City of Denton

AGENDA INFORMATION SHEET

Hold a public hearing and consider adoption of an ordinance of the City of Denton, Texas, regarding a City-initiated Comprehensive Plan Amendment to modify the Thoroughfare Map of the 2022 Mobility Plan, including but not limited to removing and realigning a proposed extension of Underwood Road between FM 1515 (Airport Road) and Springside Road, removing an east-west extension of future Corbin Road from Springside Road to existing north-south Corbin Road, and reclassifying portions of Corbin Road and Springside Road. The general area of change is located east of the City of Denton Airport, and west of I-35W in the City of Denton, Denton County, Texas; adopting an amendment to the City's official mobility plan; providing for a penalty in the maximum amount of \$2,000.00 for violations thereof; providing a severability clause and an effective date. The Planning and Zoning Commission voted 4-0 to recommend approval of the request. Motion for approval by Commissioner Dyer and seconded by Commissioner McDuff. (MPA25- 0001b, Underwood, Corbin, and Springside, Sahar Esfandyari).

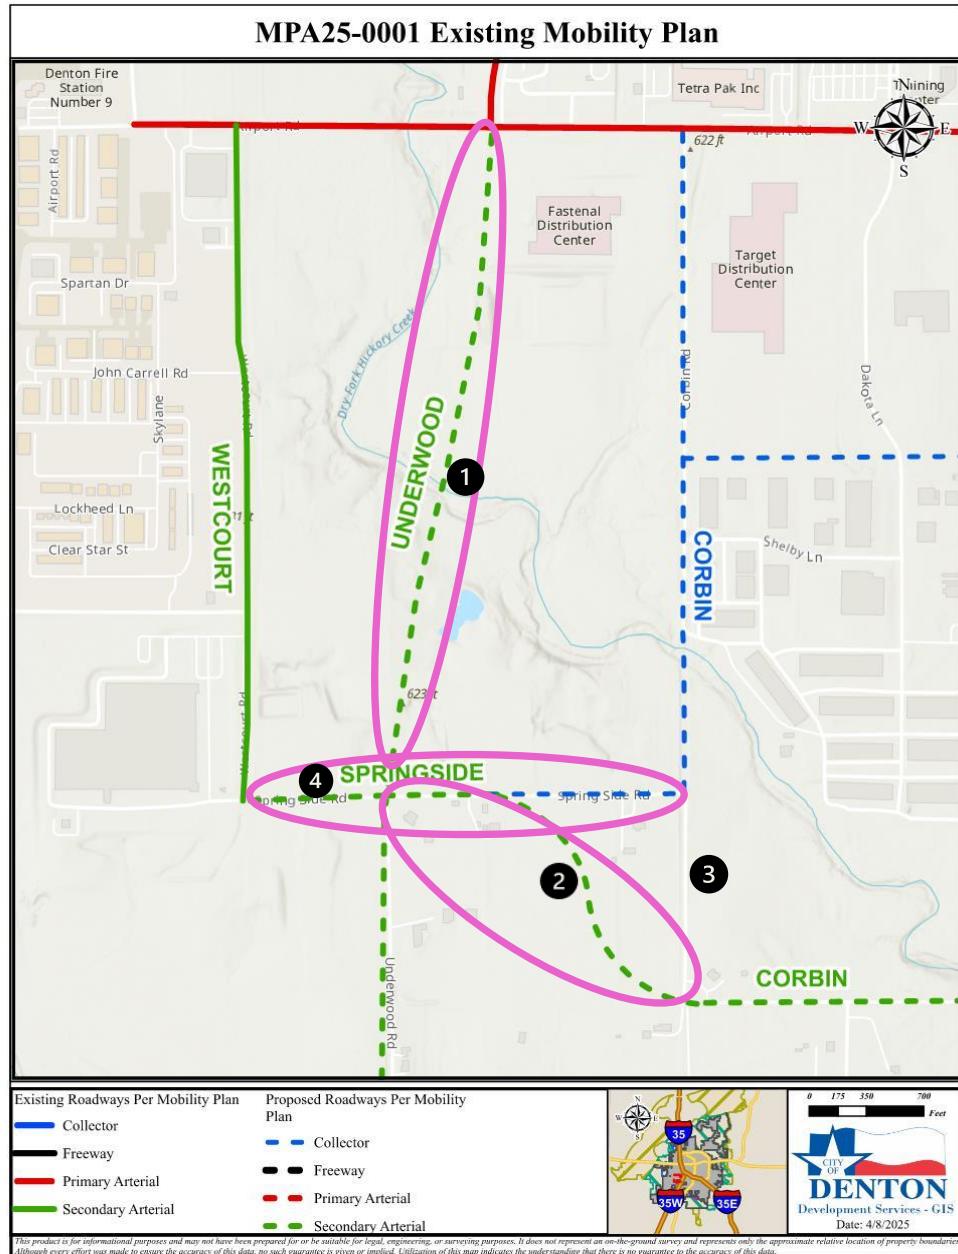
1. Removing a portion of future Underwood Road, extending from FM 1515 to Springside Road, and instead realigning Underwood Road to align with Westcourt Road.
2. Removing the proposed realignment of future Corbin Road as shown on the Mobility Plan, extending west from the existing north-south segment of Corbin Road to Springside Road.
3. Extending the functional classification of the north-south segment of Corbin Road, southward to the intersection with the east-west segment of Corbin Road, as a Collector roadway.
4. Downgrading the functional classification of Springside Road from a Secondary Arterial to a Collector.

Existing Underwood Road runs north-south from its current northern terminus of Springside Road to its southern terminus at FM 2449. However, according to the Mobility Plan, the ultimate configuration of Underwood Road will stretch from Airport Road (FM 1515) to the north to the future extension of H. Lively Road to the south. The section of Underwood Road recommended for removal under this Mobility Plan amendment is located between Airport Road and Springside Road, crossing the Dry Fork Hickory Creek. Therefore, staff recommends modifying the Mobility Plan's Thoroughfare Plan Map to remove this portion of Underwood Road as shown on the map above (and in Exhibit 5) and instead realigning it with Westcourt Road north of Springside Road as shown in Exhibit 6.

I-35W). The segment of Corbin Road being realigned as part of this request lies between north-south Corbin Road and Springside Road. This future segment would cross three residential parcels of land; therefore, staff recommends updating the Mobility Plan's Thoroughfare Plan Map and remove the future extension of east-west Corbin Road between north-south Corbin Road and future Underwood Road.

The northern terminus of the existing north-south Corbin Road is at Airport Road. However, the southern terminus, between Shelby Lane and Springside Road, is a closed, intermittent gravel road. The 2022 Mobility Plan suggested connecting the east-west segment of Corbin Road as a Secondary Arterial to Springside Road in a curvilinear fashion; however, staff is recommending the removal of that section from the Mobility Plan as noted in 2 above. Instead, staff recommends extending the functional classification of Corbin Road as a Collector, directly south from Springside Road to connect with the east-west Corbin Road. This change is shown on the map above as item 3 and also in Exhibit 6.

The existing Springside Road is situated between existing north-south Corbin Road and Westcourt Road. The 2022 Mobility Plan designated the eastern portion of Springside Road as a Collector (65 feet of total right-of-way (ROW) and 30-35 miles per hour (mph) speed), while the western portion of the road was designated as a Secondary Arterial (110 feet of total ROW and 35 mph speed). After a thorough examination of the area, staff recommends that the Mobility Plan's Thoroughfare Plan Map be updated to classify the entire road as a Collector.
